## **Addendum No. 1**

To:  
New Community Building  
Trumann Housing Authority  
Trumann, AR  
April 16, 2024

The Plan holder's attention is hereby directed to the following changes in the drawings and specifications.

1A ROOF PLAN  
 SCALE: 3/16" = 1'-0"

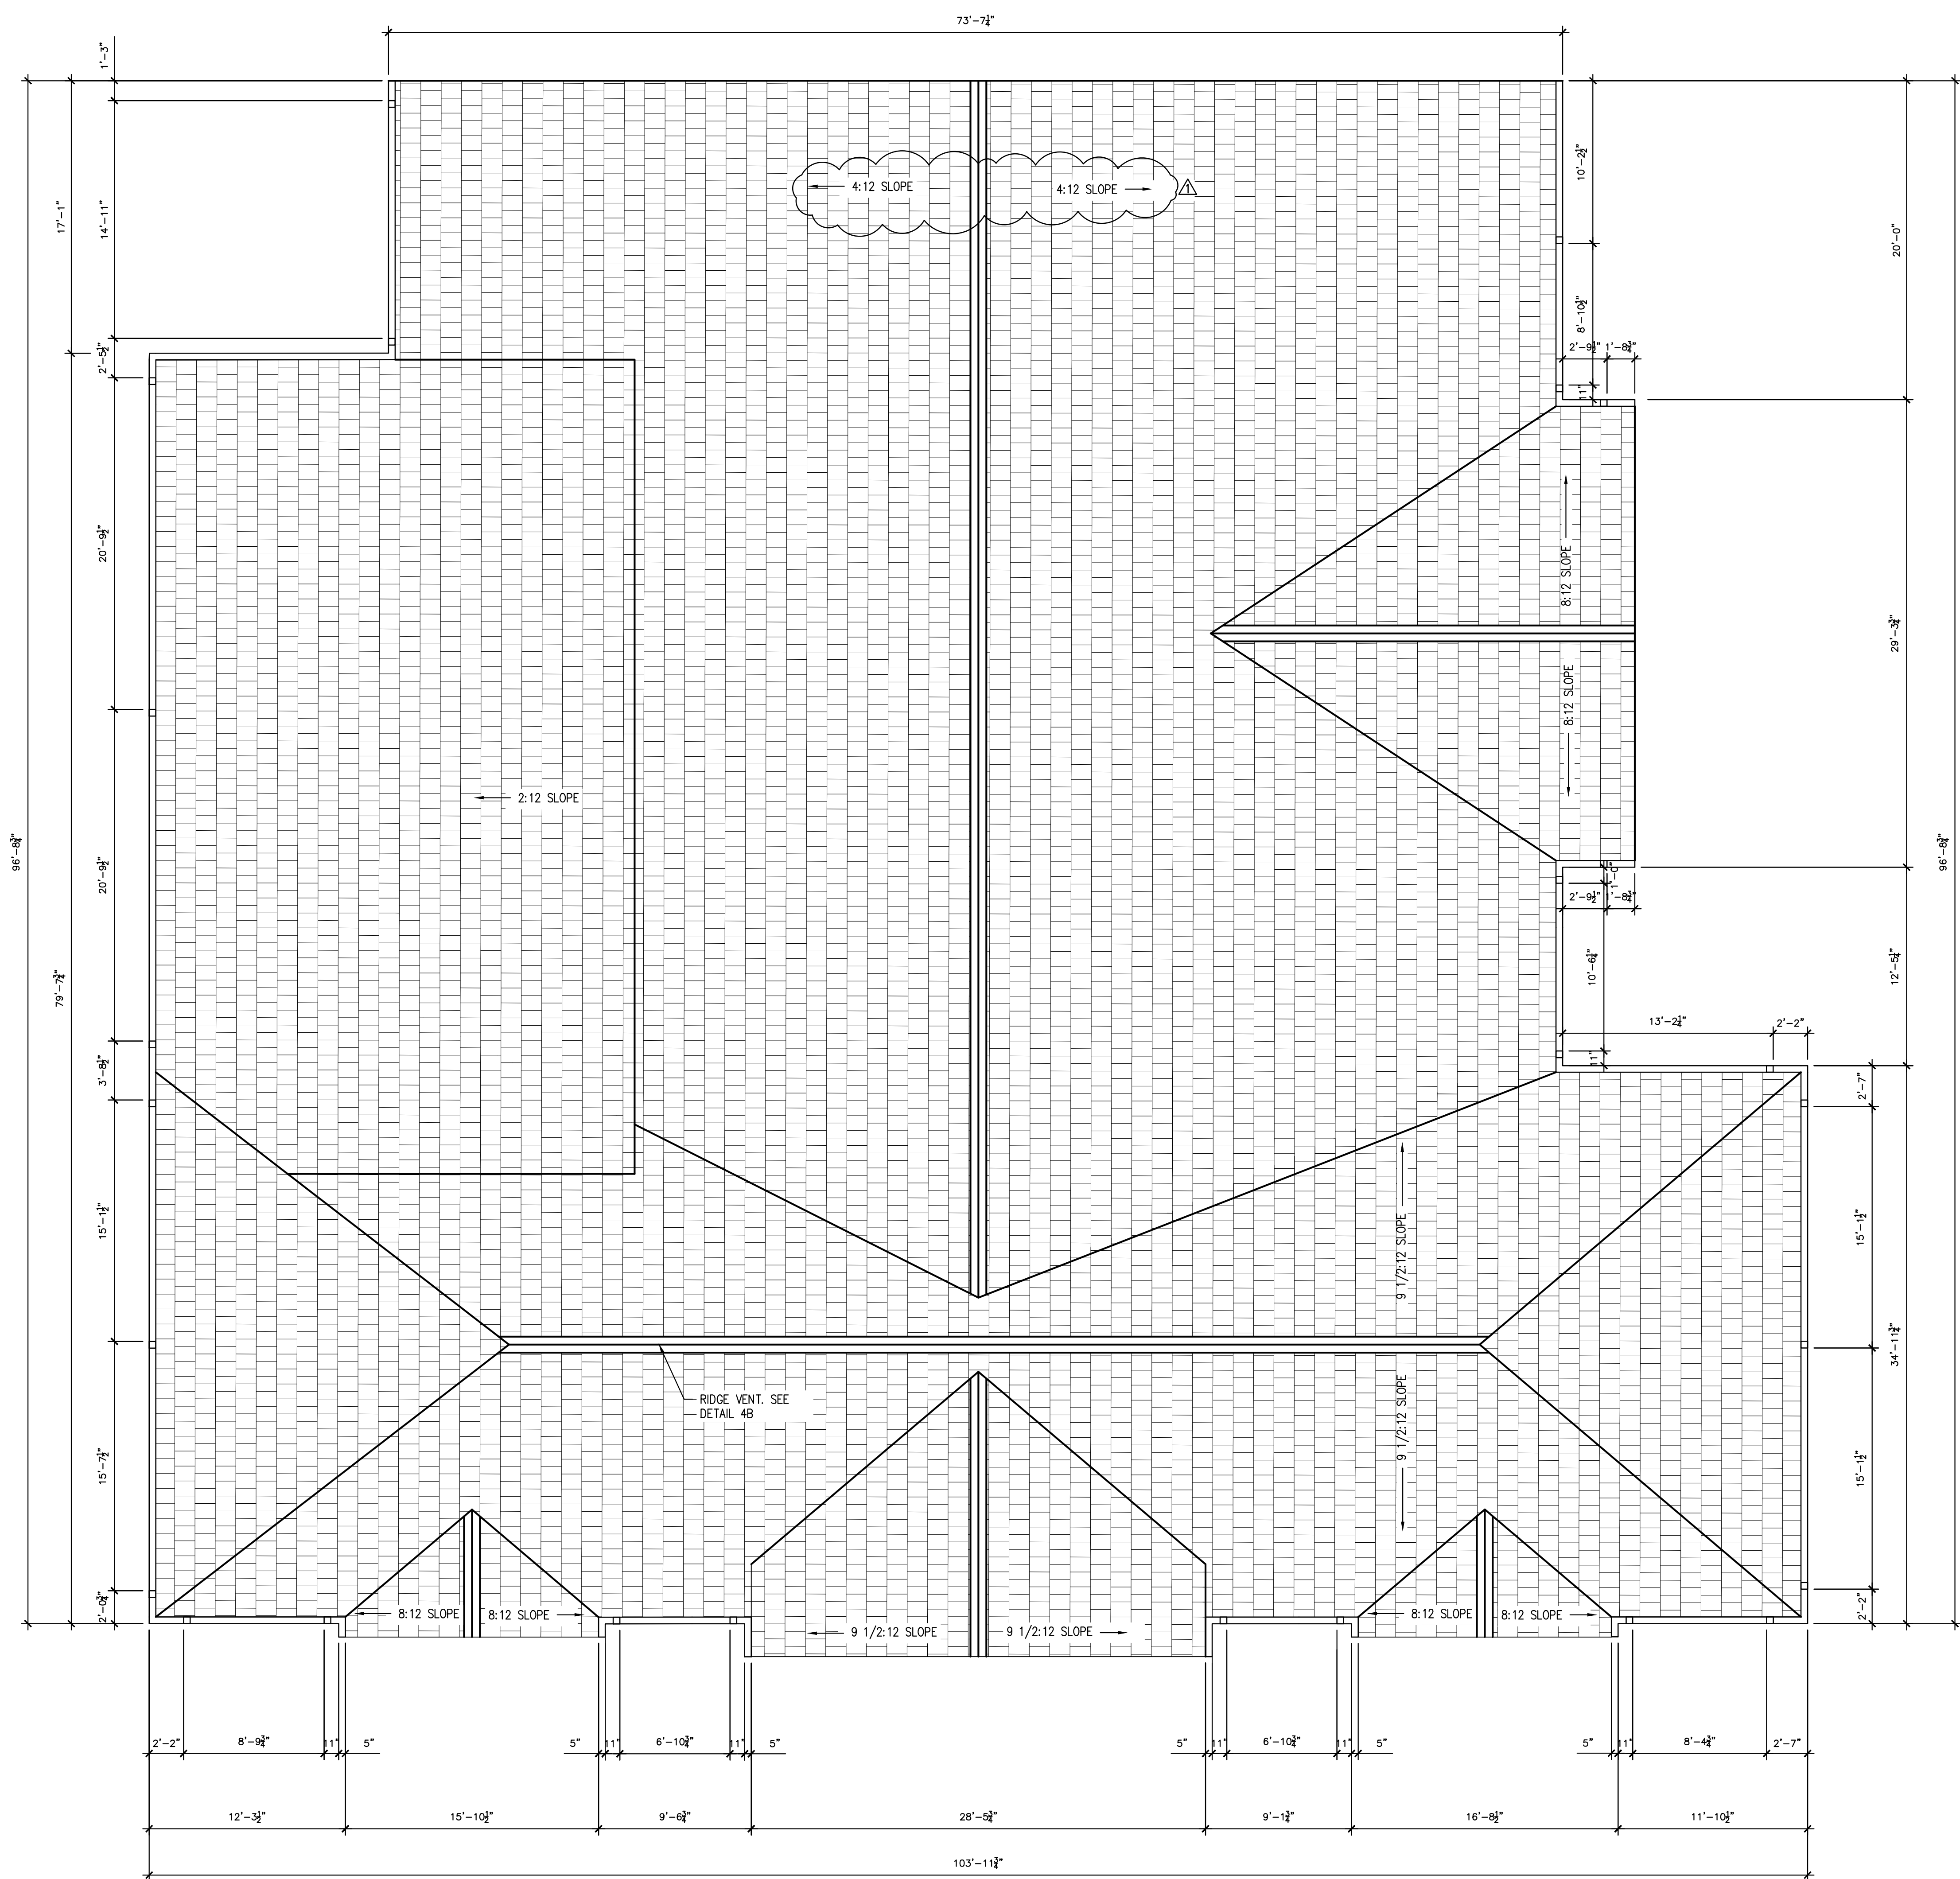
- Item No. 17:**   **Drawing Revision:** Sheet A-03, Main span pitch is labeled 5:12 but should be 4:12. See revised sheet.

**A-05.1**

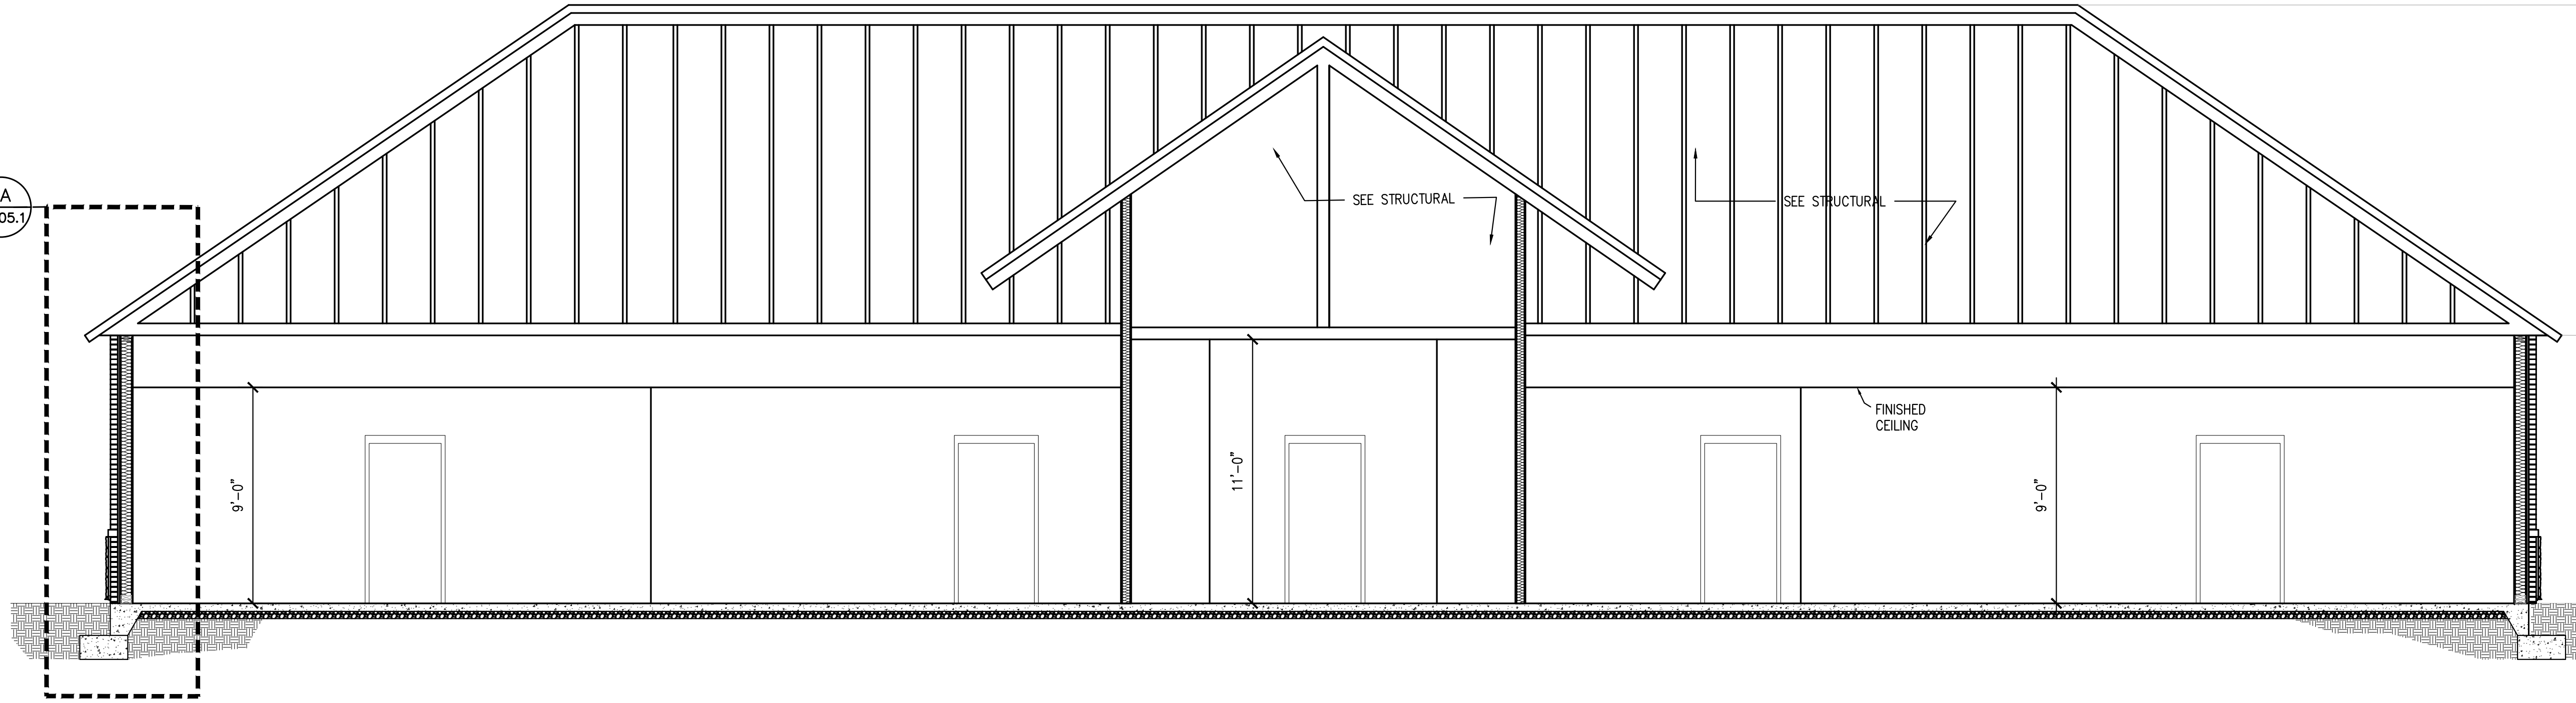
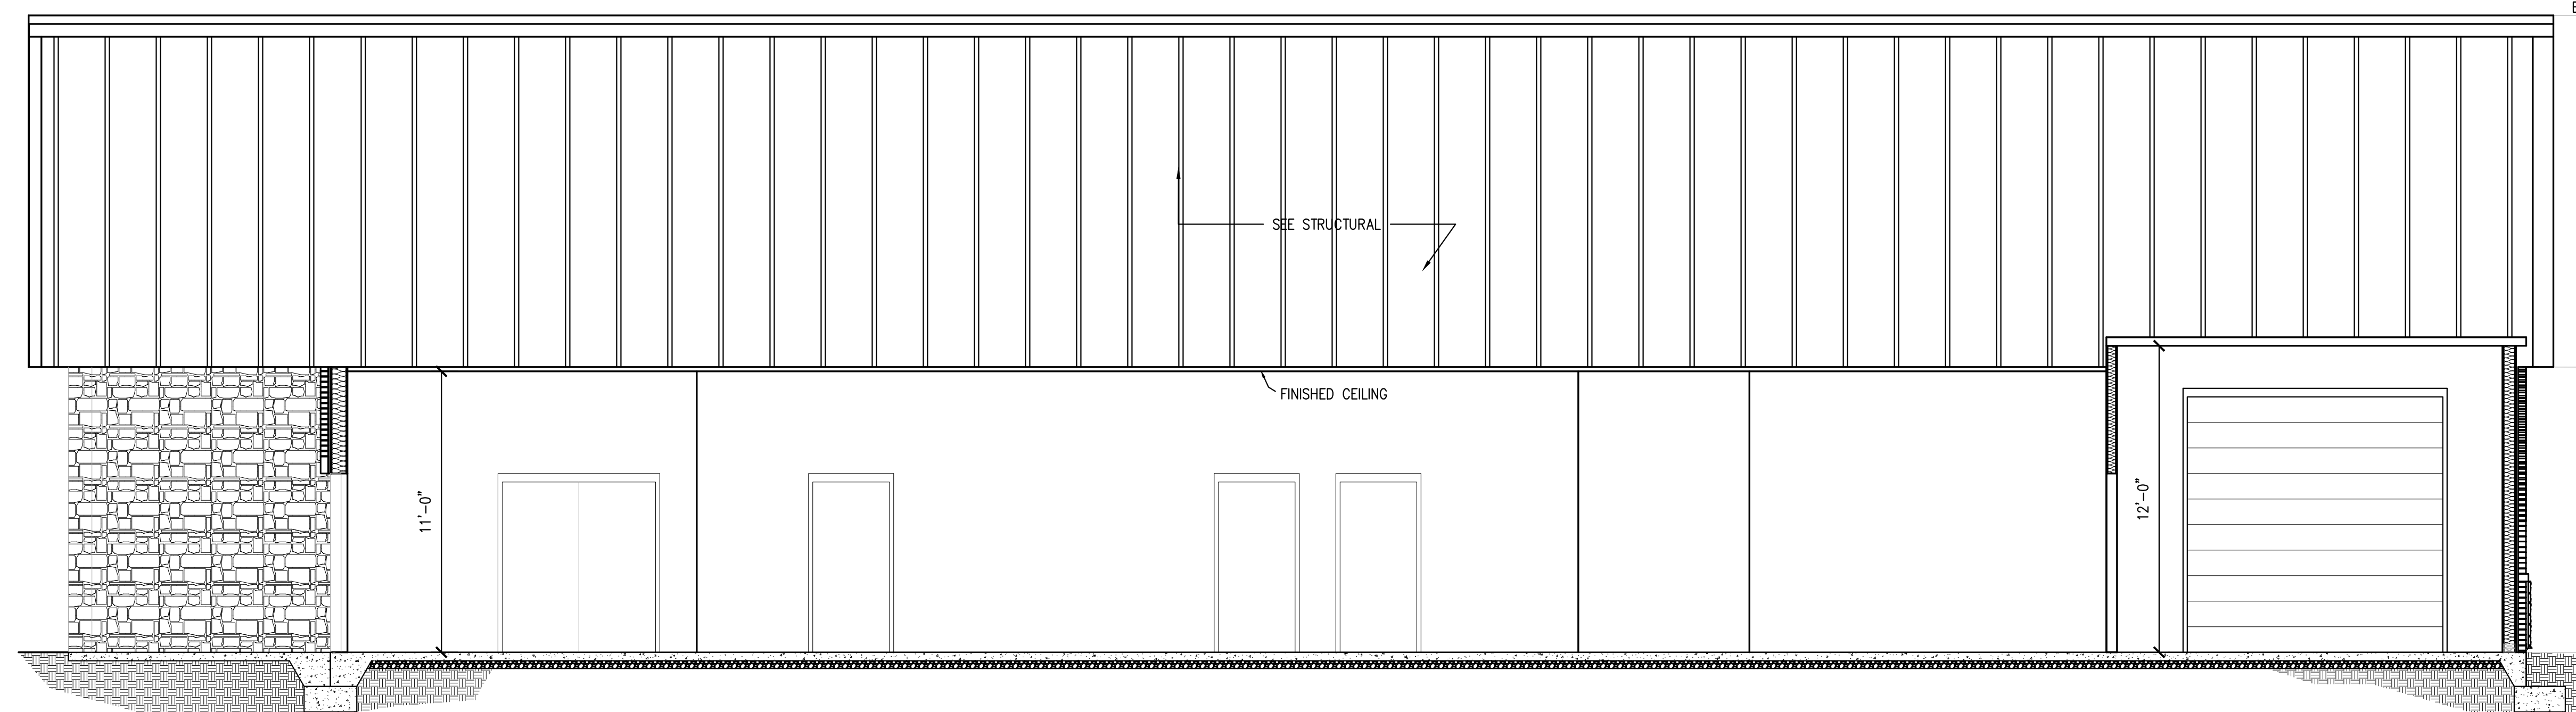
- Item No. 1:** **Revised Drawing:** Stone and Brick Masonry Wall Detail (Revised detail 1A/A-05.1 and 1B/ A-05.2 attached). Contractor may utilize different methods of masonry support for the stone veneer/brick wall with Architect's approval.
